US Army Corps
of Engineers®
Portland District

Bonneville Lock and Dam
Columbia River Basin, Washington - Oregon

Hydraulic Evaluation of Lower Columbia River Adult Bypass Systems (HELCRABS)

Bradford Island 'B' Branch Adult Fishway Evaluation

Plate 2
Bradford Island B Branch Ladder
Layout

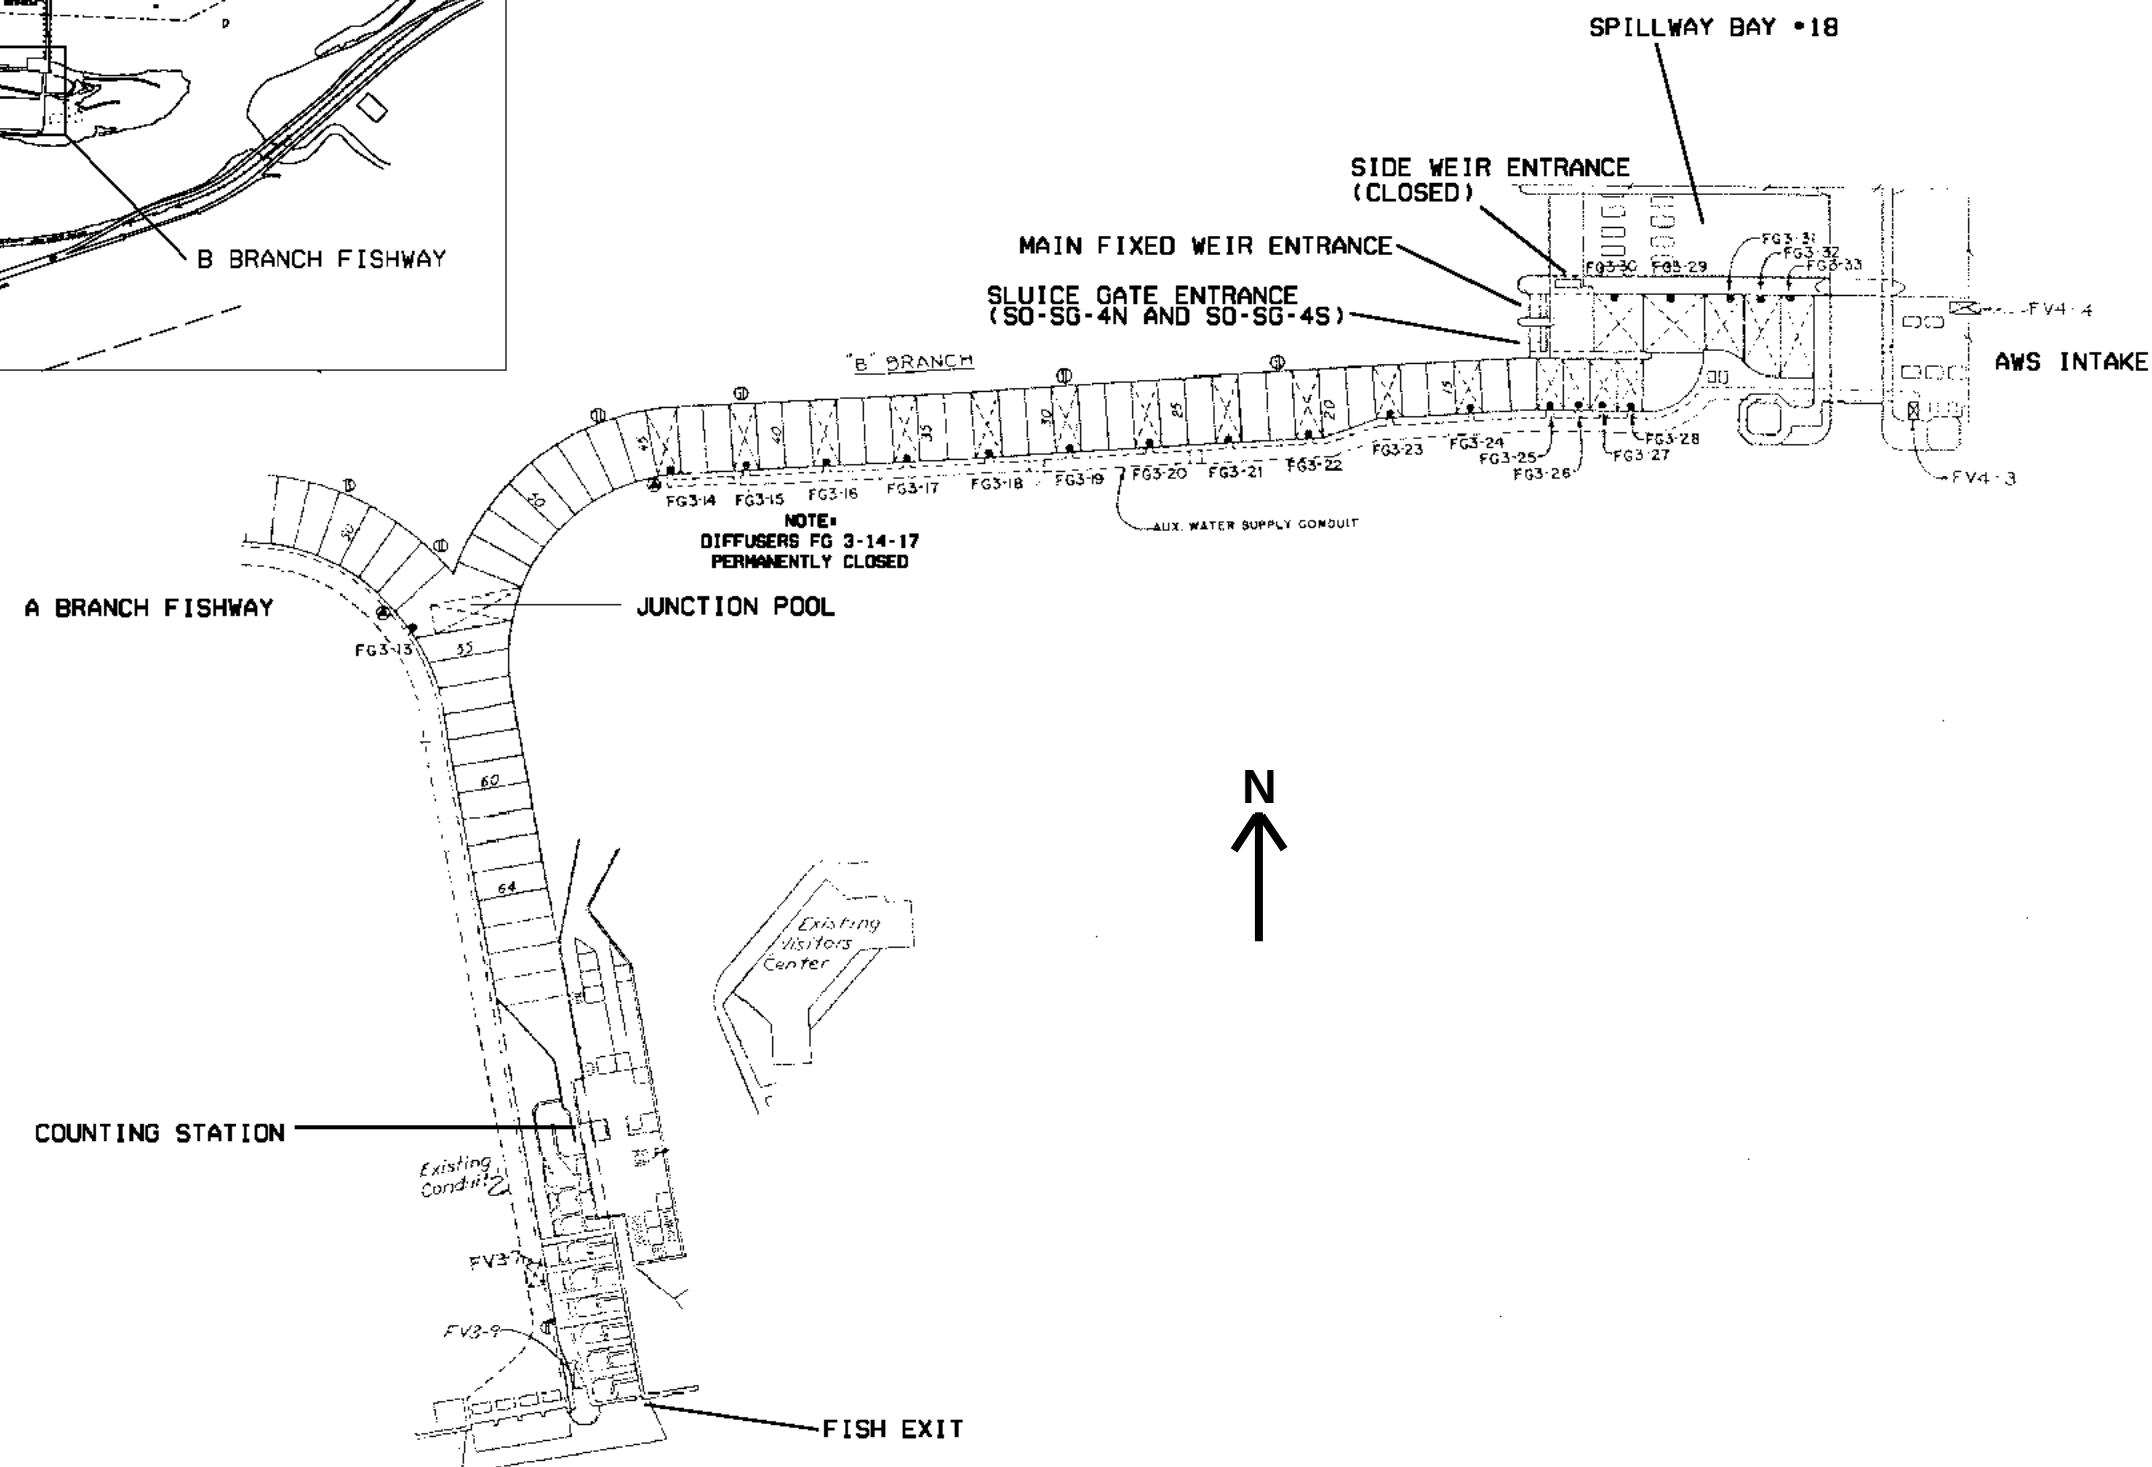
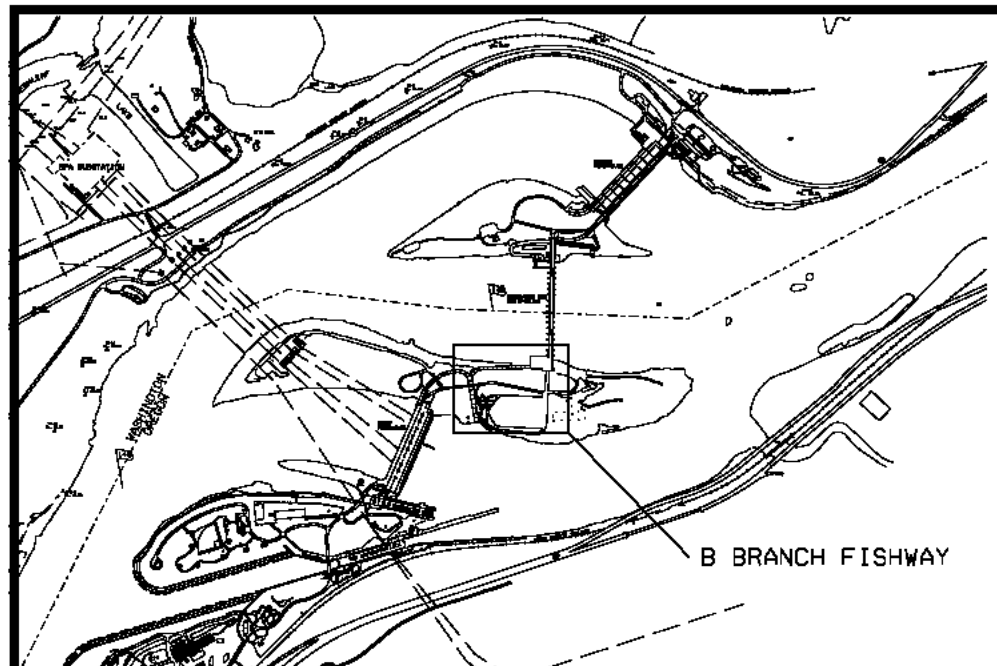
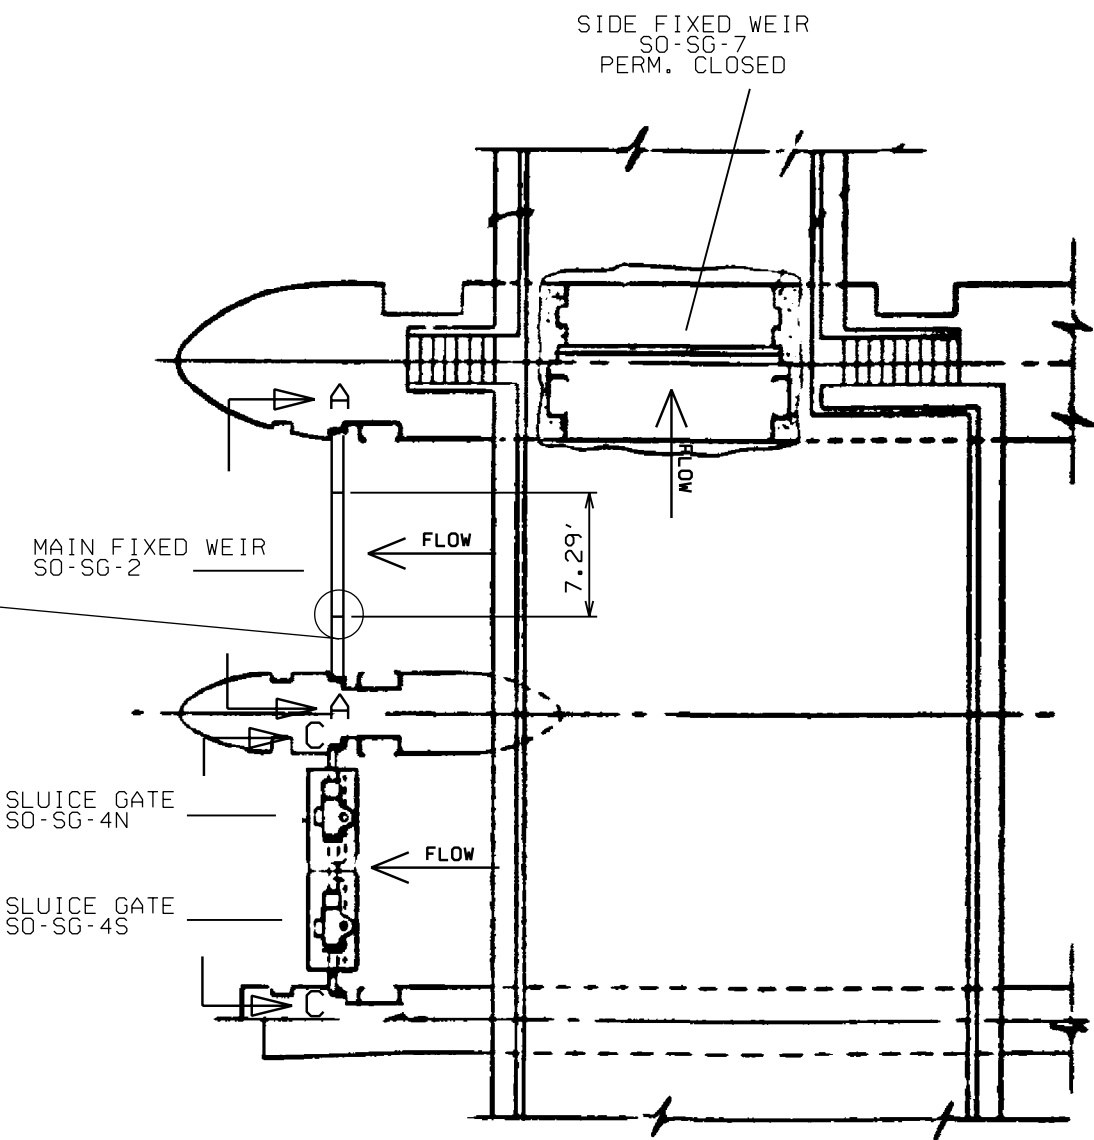
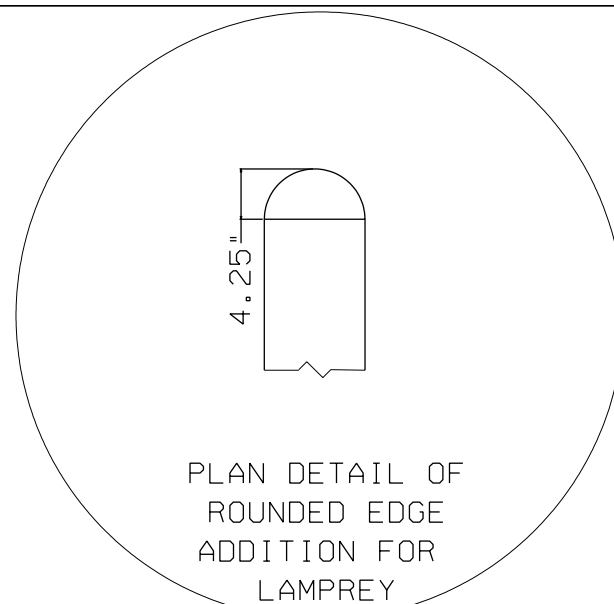
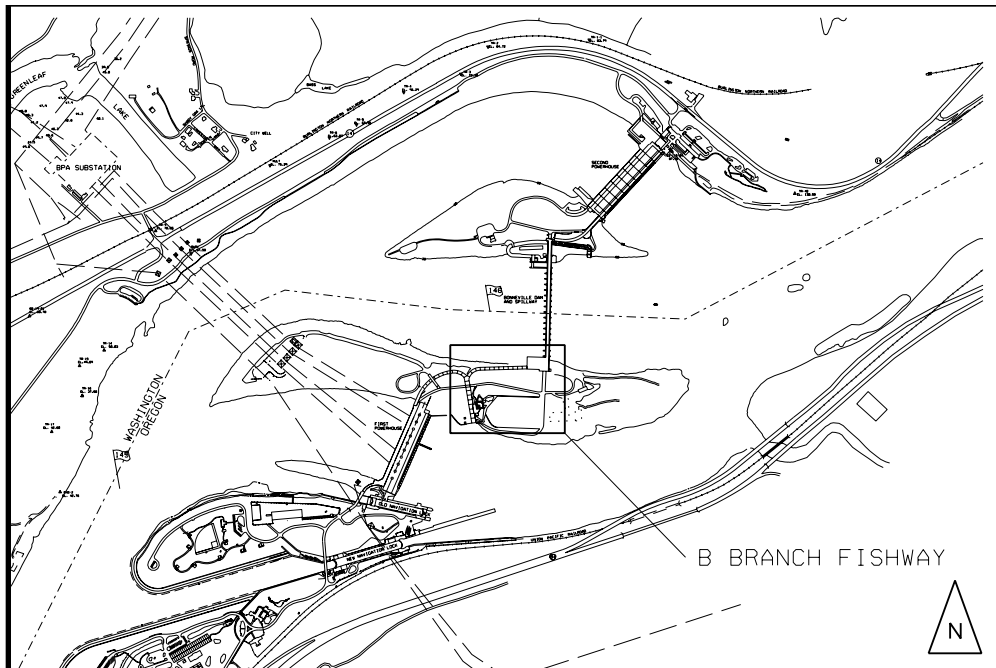
1) 4th sentence- Plate?? Add north arrows to Plate 2 and 3 2) 2nd to last page- From there, the flow 3) 2.2.2.1 Fish Valve 4-3...- 5th sentence- downstream end (weir 45)--> downstream end at weir 45. 4) 2.2.3 Overflow...- through 20, and to 40 ft--> through 20 to 40 ft 5) bullet 2- clarify "lower set" and "lower one" lower one measures? (Submitted 15-Jun-04 by Natalie Richards Natalie.A.Richards@nwp01.usace.army.mil (503) 808-4879.)					
1-0	Evaluation Concurred 1) Reader referred to Plate 2. Plate 2 has north arrow. Added north arrow to Plate 3. 2) Punctuation added. 3) Change made to clarify. 4) Change made to clarify. 5) Text changed to clarify. (28-Jun-04 by Kyle McCune Kyle.C.McCune@nwp01.usace.army.mil (503) 808-4835)				
1-1	Backcheck Recommendation Open Comment 1)Couldn't find N arrow on Plate 3?2) In general--> Is a capital W needed when a specific weir is listed?I am not sure. Recommend consistency throughout the document which ever way. Page 6? 2.2.2.1 Wier 45 OR 2.2.3 weirs 18 3) In general, need page numbers for the document (21-Jul-04 by Natalie Richards Natalie.A.Richards@nwp01.usace.army.mil (503) 808-4879).
